CITY OF ROOSEVELT PARK
City of Roosevelt Park
PLANNING COMMISSION
AGENDA
September 25, 2023
6:00 p.m.

6. New Business
 - a. Site Plan Review-3145 Henry Street-Consumers Credit Union

**Subject: Consumers Credit Union Branch, 3145 Henry Street
Site Plan Review**

Re: Consumers Credit Union
Site Plan Review Response

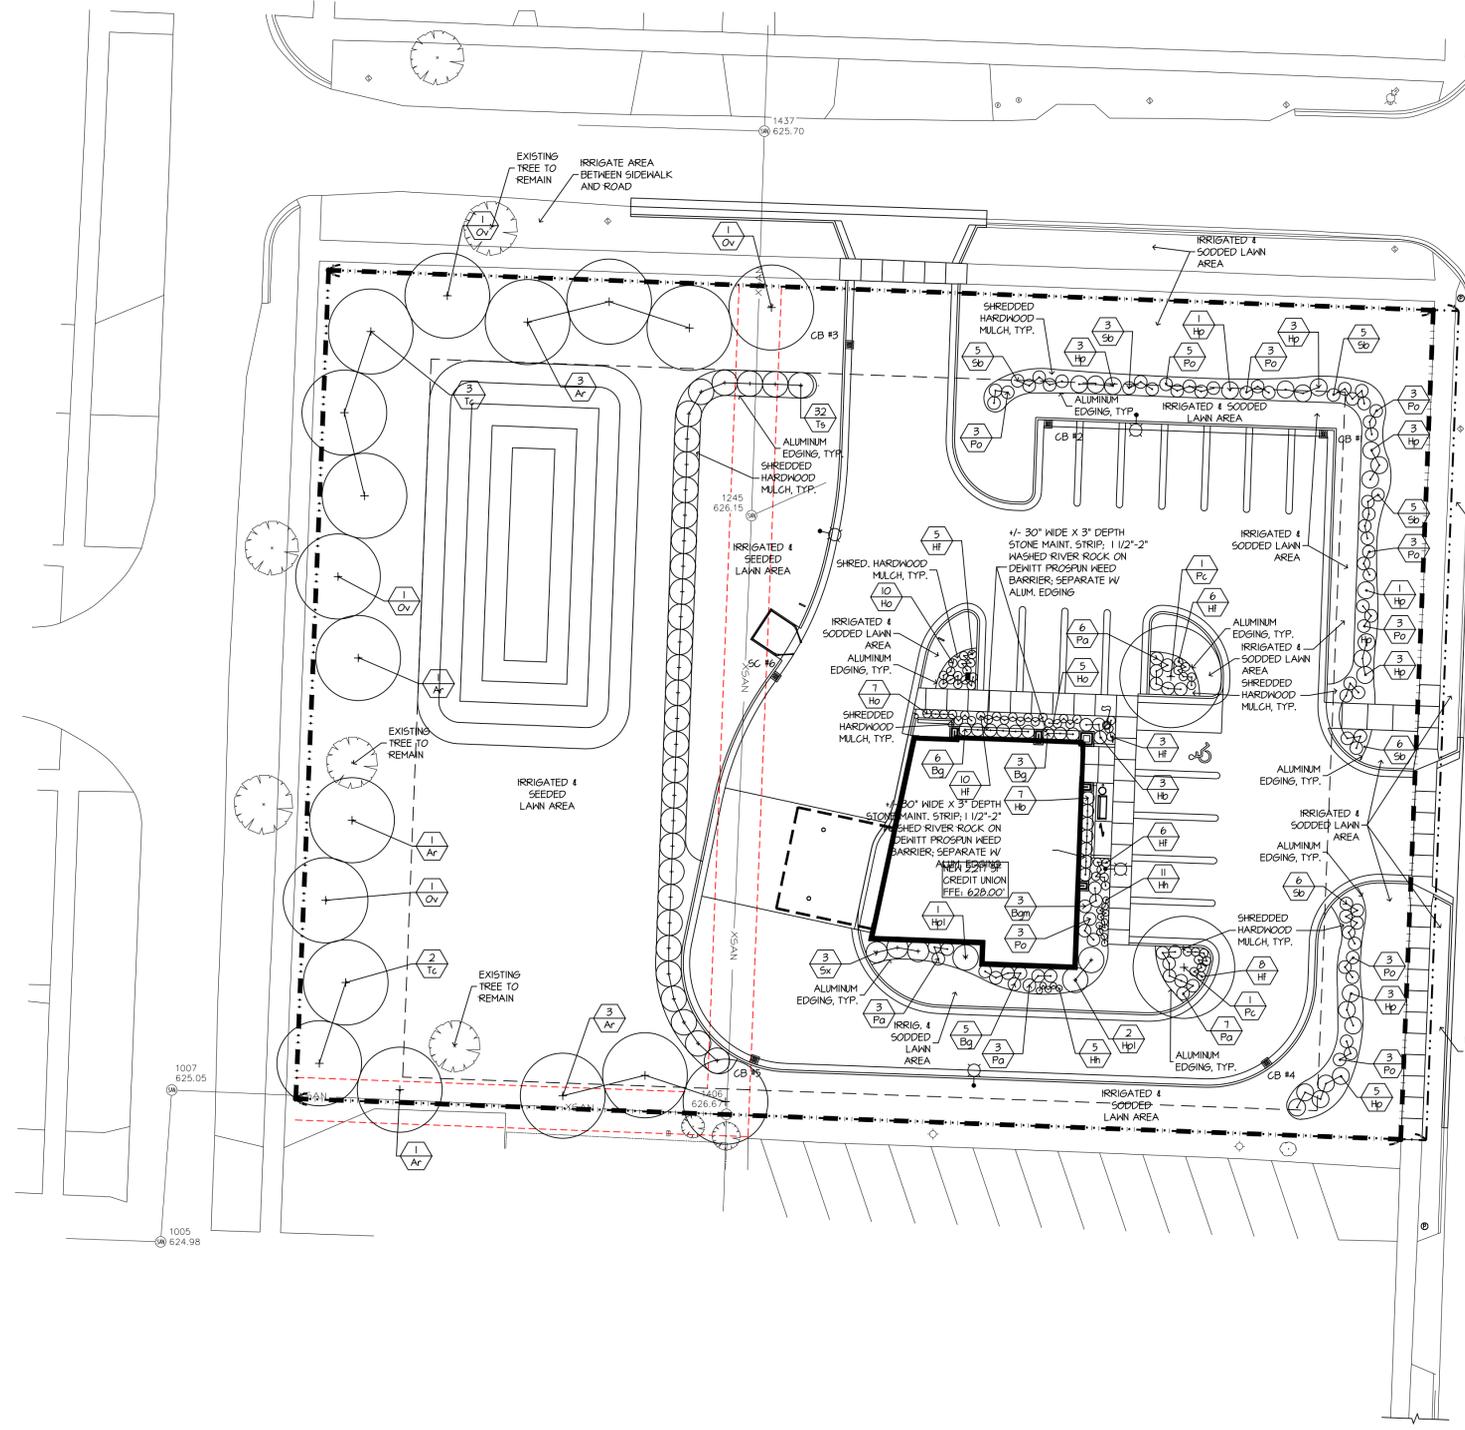
The front screening proposed by Consumers Credit Union is a mulched area containing shrub plantings between the parking area and the road. The remainder of the space to the right-of-way would be grass lawn. The site plan describes the provided landscape screening as a "shrub hedge"

- b. Buffer Landscaping.** According to Section 11.2, buffer zones are required to screen the more intensive C-E district from the R-1 district. The required buffer zone can be reduced by one level when separated from the district by a street. With this in mind, a moderate buffer zone is required to the Southwest to provide screening between the site and a single-family home. A minor buffer zone is required along the east side of the property and the northeast corner of the property.

To fulfill the 6-foot obscuring screen requirement, the applicant proposes a row of 32 evergreen trees spaced approximately 10 feet apart. The row of trees will be along the drive-through lanes in the rear, 100-feet from Lindland. The applicant plans to use *green giant arborvitae* trees, which are dense evergreens that create a solid screen. Along the sidewalk, the applicant proposes planting 17 new canopy trees across (there are two existing trees which will remain). In the area between the canopy trees and the sidewalk the applicant proposes a retention pond

The rear landscaping plan meets the requirements of the Ordinance. However, we recommend that more of the existing trees be saved, rather than replacing them with younger, less mature trees.

A 20-foot buffer zone is required between the single-family home to the southwest, to include two rows of canopy trees staggered at a maximum 20-foot interval and a 6-foot tall continuous obscuring screen (11.2.F). The required trees are included on the plan, but there is no obscuring screen, unless the Planning Commission counts the arborvitaes along the edge of the parking lot. The Commission should determine whether those are sufficient.

- e. Dumpster Landscaping:** Section 11.3.E requires a continuous opaque screen (berming, plant material, screen walls or fences) to surround all dumpsters. We recommend that the proposed dumpster enclosure and the row of evergreens west of the parking lot be considered sufficient to meet this requirement.

A 6' high fence will be added at the southwest corner of the site to obscure the adjacent residential property.
